PUBLIC UTILITIES COMMISSION OF SRI LANKA

**DECISION ON
LEAST COST LONG TERM
GENERATION EXPANSION PLAN
2018-2037**

This Document contains the decision of the Commission on the Least Cost Long Term Generation Expansion Plan for the period of 2018-2037, prepared by the Ceylon Electricity Board (Transmission Licensee operating under License No EL/T/09-002) in terms of Section 43 of the Sri Lanka Electricity Act No. 20 of 2009 as amended by section 13 of Sri Lanka Electricity (amendment) Act No. 31 of 2013

Table 2: Fuel Prices

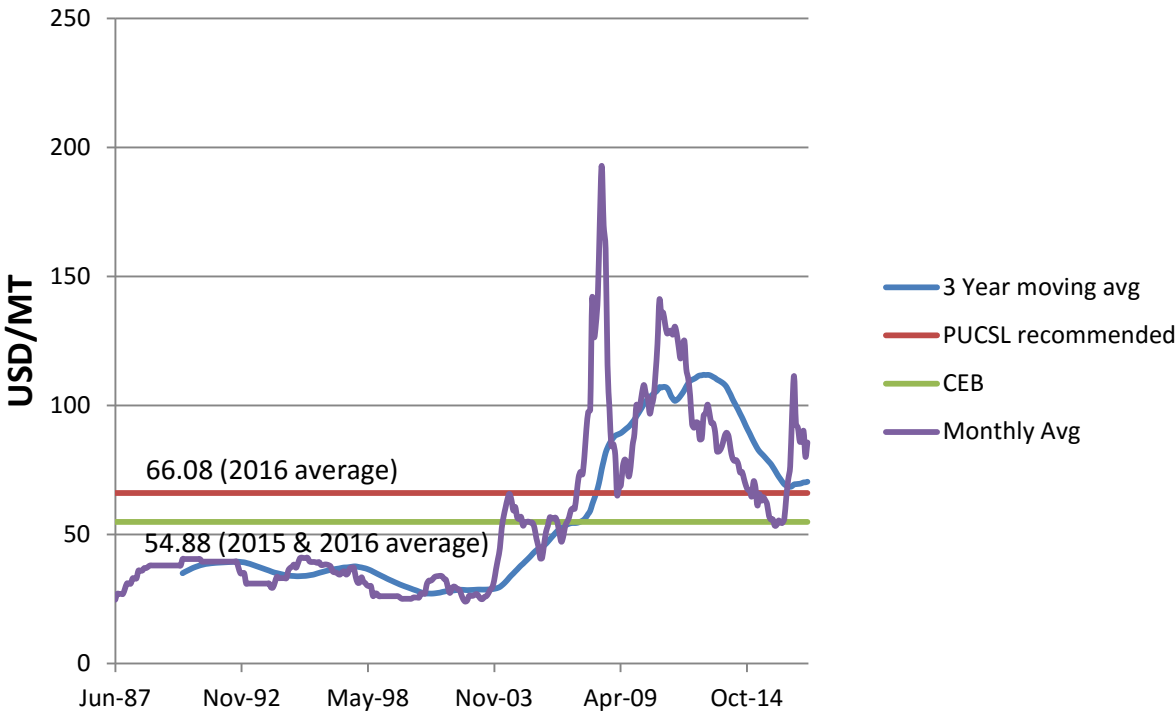
CEB has based its fuel cost assumption from Lanka Coal (coal price for Puttlam coal plant), Ceylon Petroleum Corporation (oil prices) and Japanese Crude Cocktail (JCC) basis (NG prices). However, those costs are not fully reflected in the published Platts (Singapore), JCC and NEWC indexes (Australian coal index published by www.Globalcoal.com) at the end of the year 2016. During the presentation on the draft LCLTGEP by CEB, it was revealed that it relied on two year (2015 and 2016) average market prices for fuel cost estimates. Using such long term (2015 and 2016) average, when the current prices are substantially different (Table 2) appears to misrepresent the actual pricing at the time of preparation of the plan. Most notably, they have used the existing market prices for oil products (which is with taxes, etc and excessively higher than the border prices).

The PUCSL recommended fuel prices compared to long term price (spot LNG prices for Japan (METI website) and Australian coal prices (www.Indexmundi.com)) trends are shown below. The 2016 average fuel prices were recommended considering the recent step increase in coal prices and the recent gradual reduction in LNG prices. In case of coal; CEB coal price (FOB) assumption is clearly below the current price levels, as opposed to LNG; where CEB price is higher than the current price level. When comparing with the three year moving average prices for coal, assuming a price well below the moving average price (as proposed by CEB) is not recommended. In case of LNG, long term Asian market prices are not available and thus PUCSL recommended price (8.4 \$/MMBtu) for NG which is similar to the recommendations made by Petroleum Resource Development Secretariat, (8.3 \$/MMBtu) could be used.
